ALASKAN WAY VIADUCT

EVALUATION OF GRAY'S RETROFIT PROPOSAL

Prepared for the
Washington State Department of Transportation

By
T.Y. Lin International

Figure 24a Girder curvature ductility demand, retrofitted structure, design earthquake, upper level

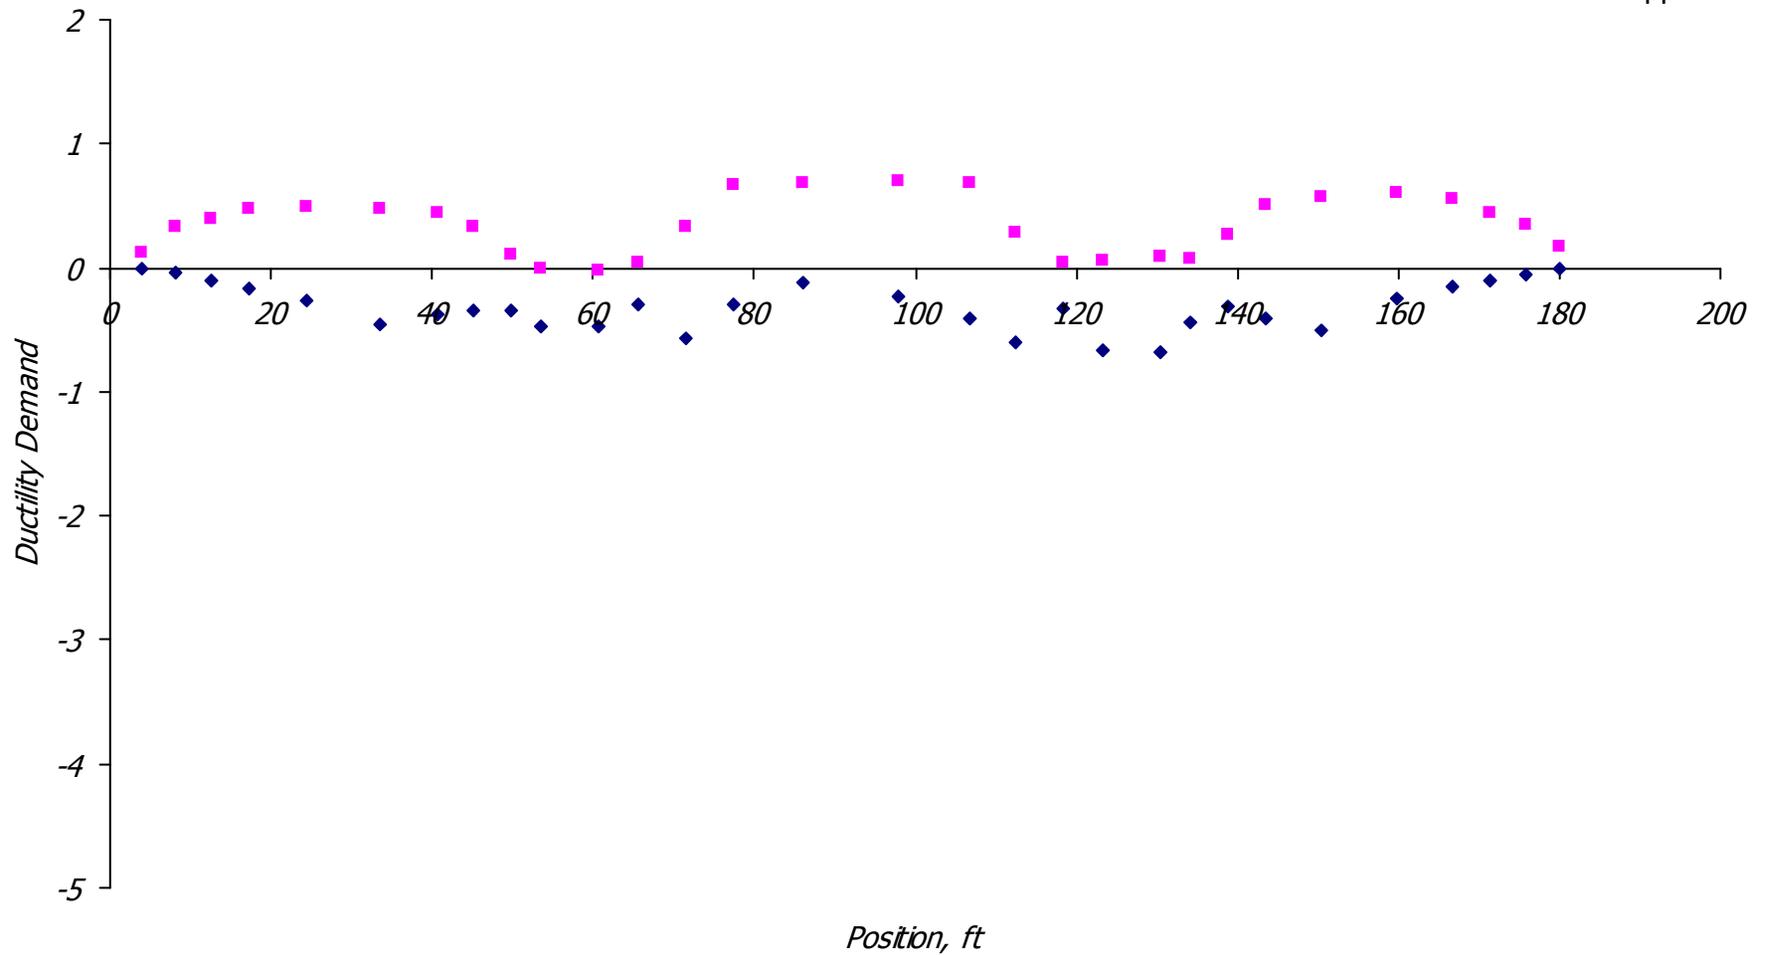
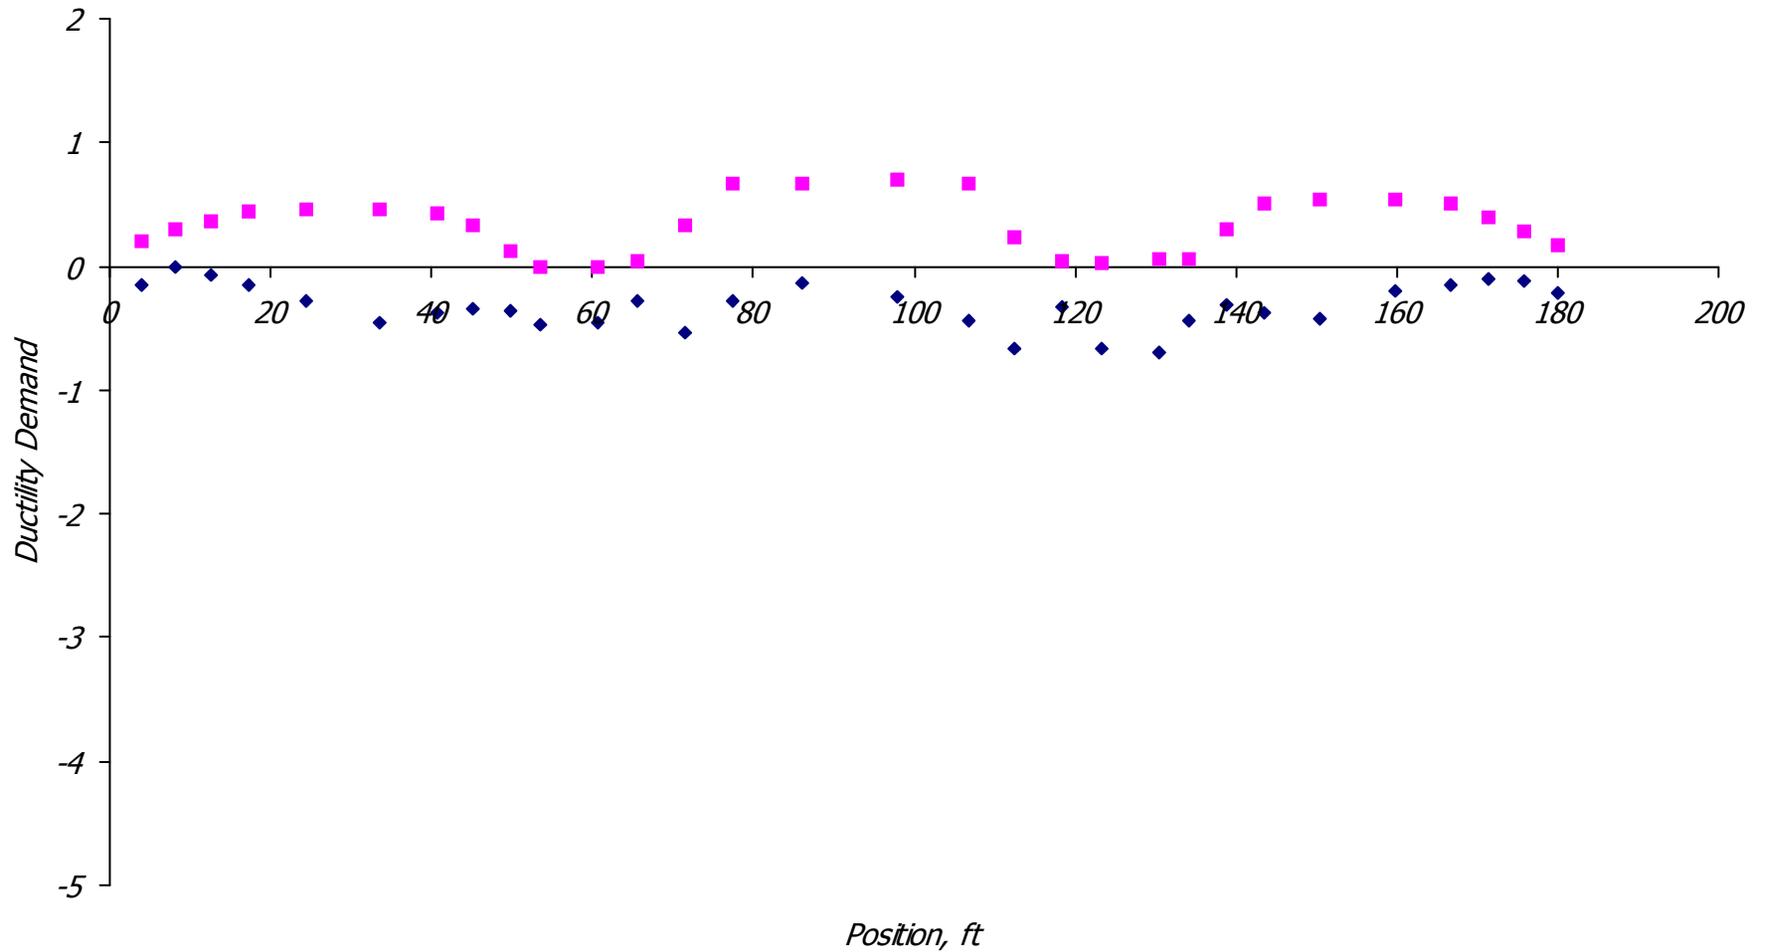
For the design earthquake, the curvature ductility demands on the edge girders are summarized in Figure 24. They are all less than unity; normally, damage would not be expected. It is likely that any pre-existing flexural or shear cracks would be further widened by a seismic event, however. Peak curvature ductility demands for the expected earthquake are about 0.4. This behavior may differ for the units design by the SED. The edge girders in these units have lighter reinforcing, and will see higher D/C ratios than the WSDOT units.

Figure D.6a Column curvature ductility demand, retrofitted structure, rare earthquake, longitudinal direction

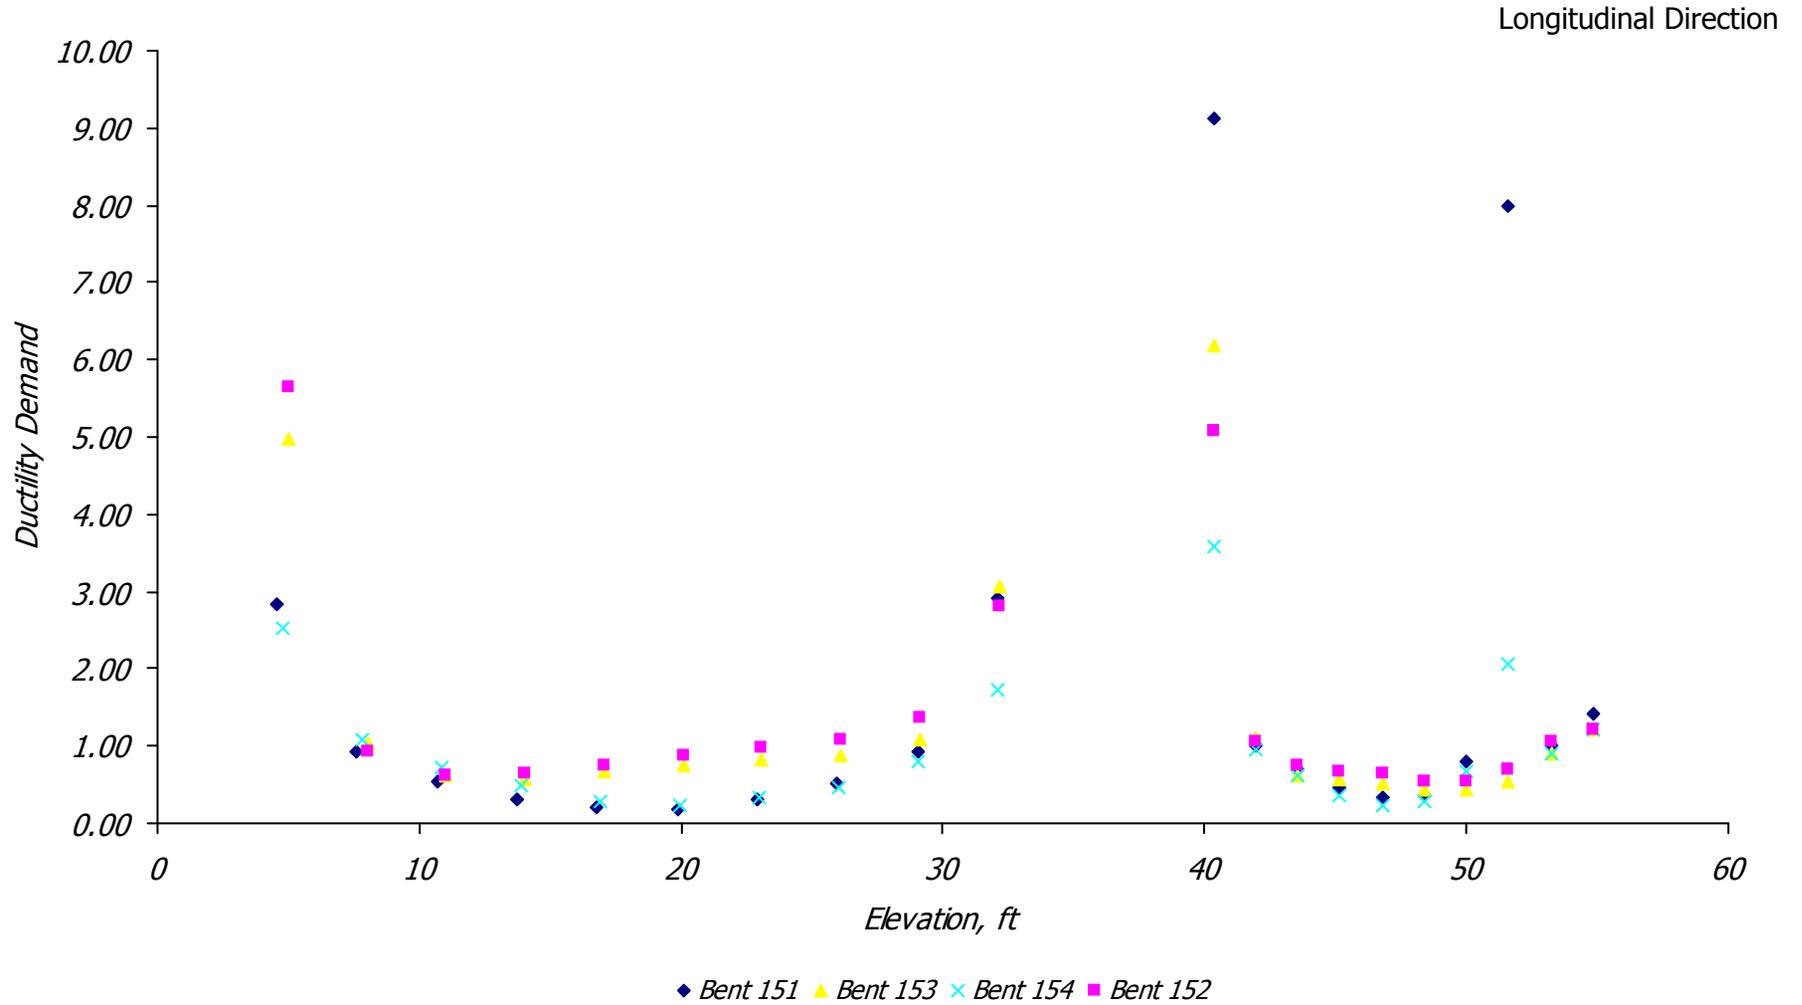
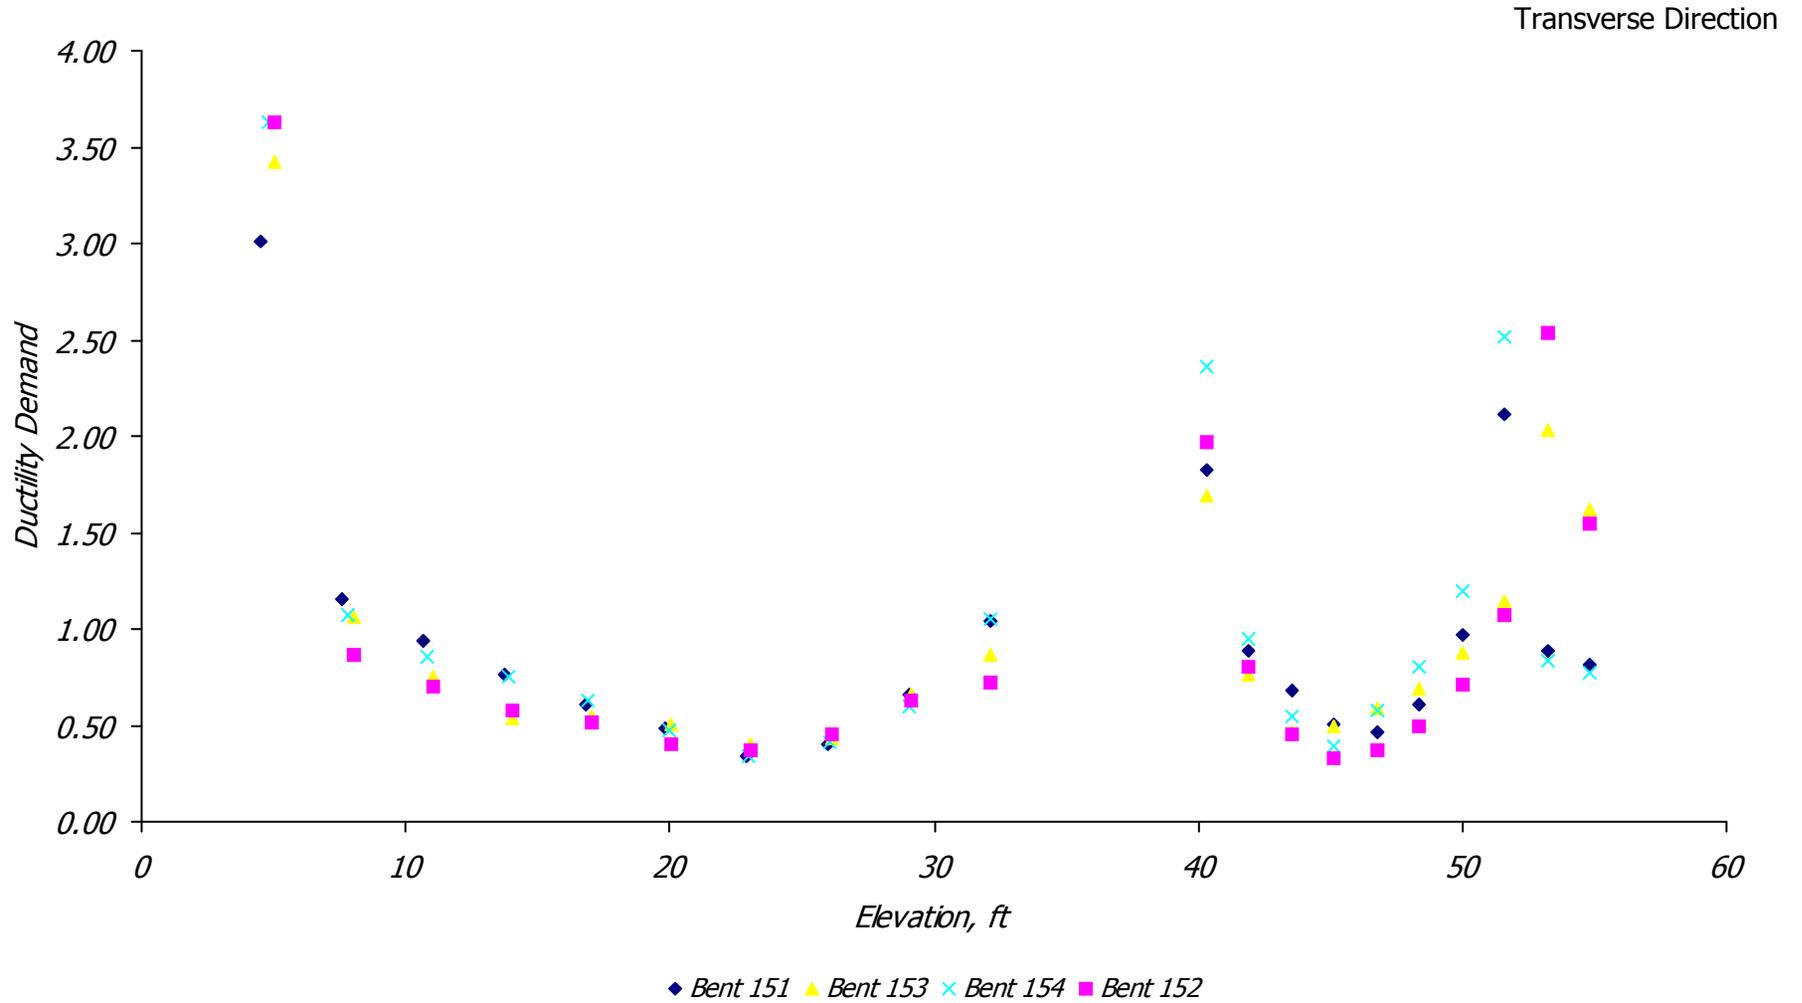
For the rare earthquake, the curvature ductility demands on the columns are summarized in Figure D.6. The plots show that plastic hinges form in the tops and bottoms of the columns, in both levels of the structure and in both directions. In the upper level columns of the end bents, the hinges don’t form at the very tops of the columns because there is additional main reinforcement at this location. The hinges form at a weaker section a few feet from the tops of the columns.
